# IC-756Pro II Technical Report: Erratum for Fig. 10, p. 16.

(excerpt from Japanese-language IC-756Pro II Technical Report, p. 16)

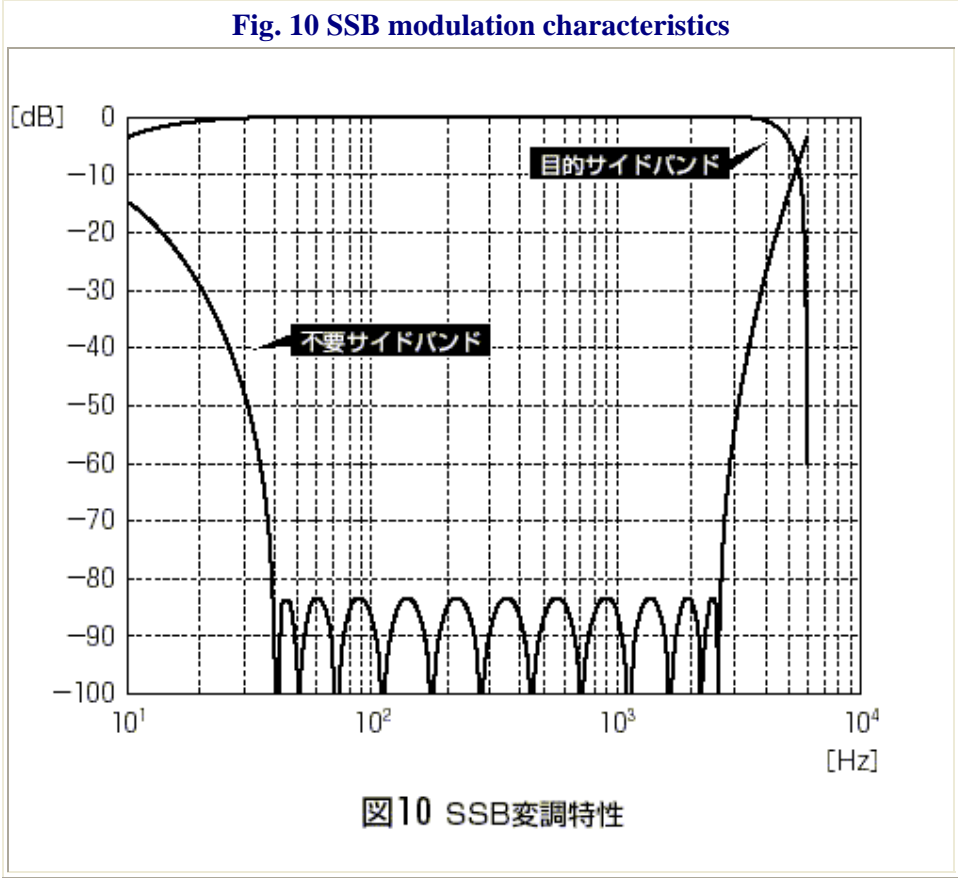
- 1. The correct scale for the X-axis [Hz] is 10<sup>1</sup>, 10<sup>2</sup> etc., not 101, 102, etc.
- 2. Upper curve: Desired sideband.
- 3. Lower curve: Undesired sideband.
